UNITED STATES  
NUCLEAR REGULATORY COMMISSION  
WASHINGTON, D. C. 20555

AMENDMENT TO FACILITY OPERATING LICENSE

Amendment No. 81  
License No. DPR-38.

ATTACHMENTS TO LICENSE AMENDMENTS

CORE PROTECTION  
SAFETY LIMITS  
UNIT 1  
OCONEE NUCLEAR STATION  
Figure 2.1-2A

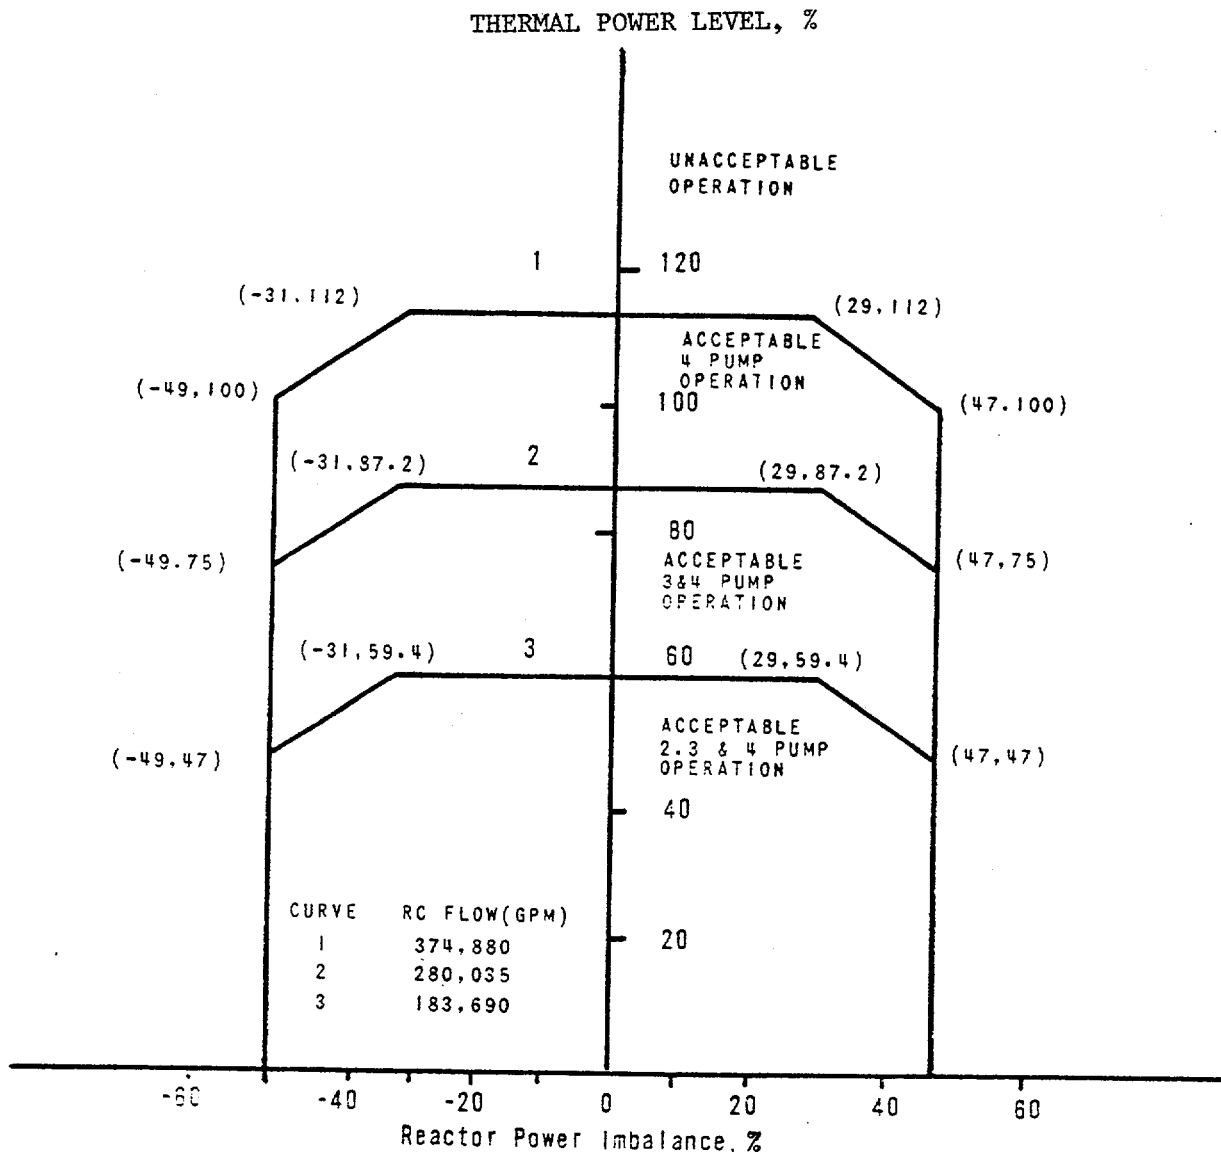
The curves of Figure 2.1-2A are based on the more restrictive of two thermal limits and include the effects of potential fuel densification and rod bowing:

The specified flow rates for Curves 1, 2, and 3 of Figure 2.1-2A correspond to the expected minimum flow rates with four pumps, three pumps, and one pump in each loop, respectively.

PROTECTIVE SYSTEM  
MAXIMUM ALLOWABLE SETPOINTS  
UNIT 1  
OCONEE NUCLEAR STATION  
Figure 2.3-2A

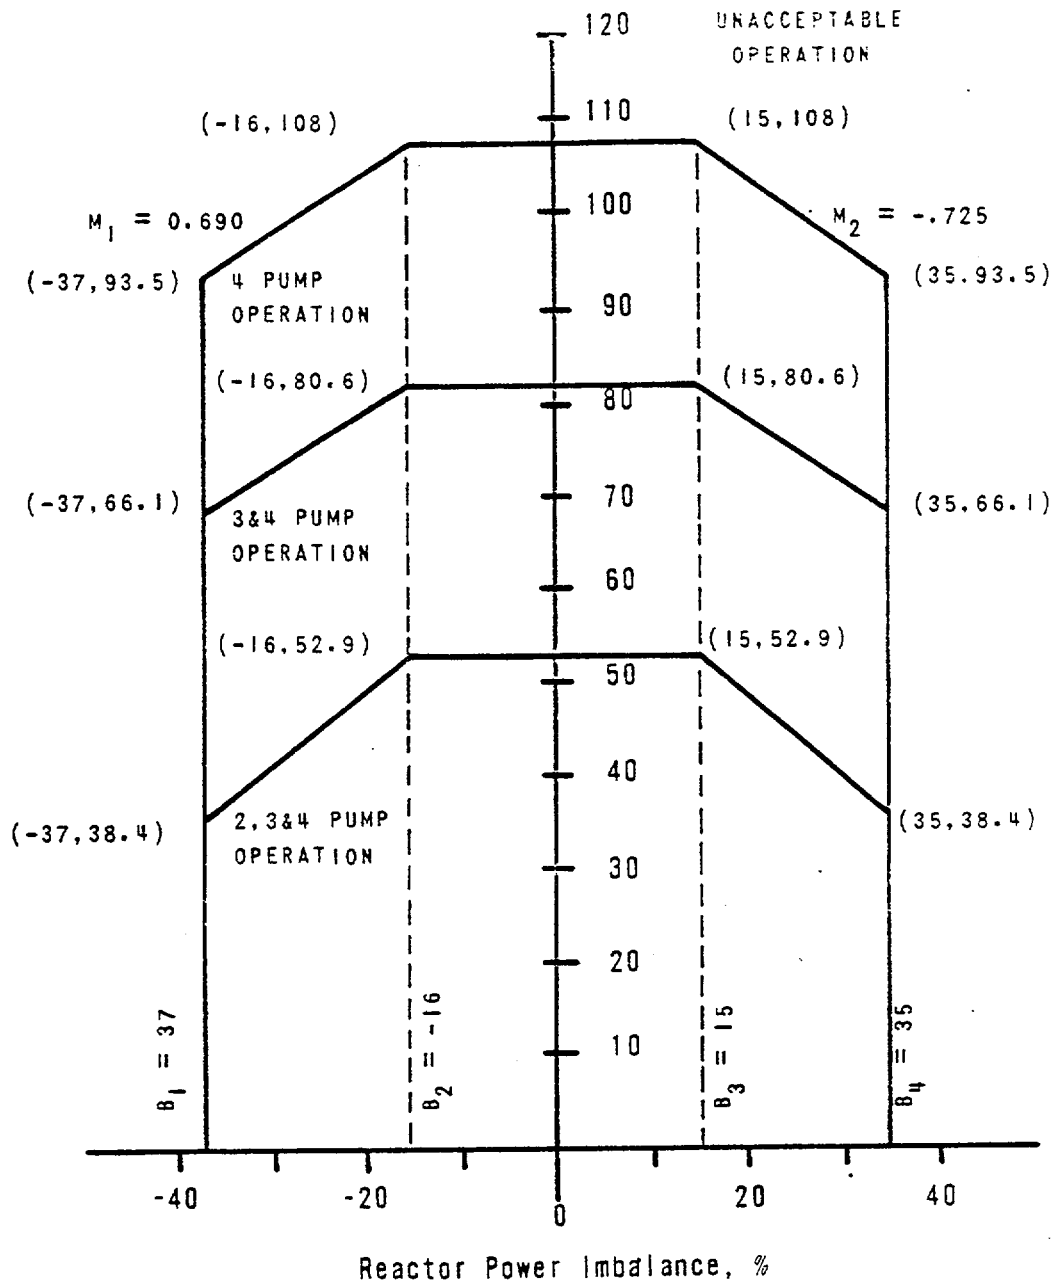
The power-imbalance boundaries are established in order to prevent reactor thermal limits from being exceeded. These thermal limits are either power peaking kw/ft limits or DNBR limits. The reactor power imbalance (power in the top half of core minus power in the bottom half of core) reduces the power level trip produced by the power-to-flow ratio such that the boundaries of Figure 2.3-2A - Unit 1 are produced. The power-to-flow ratio reduces the power
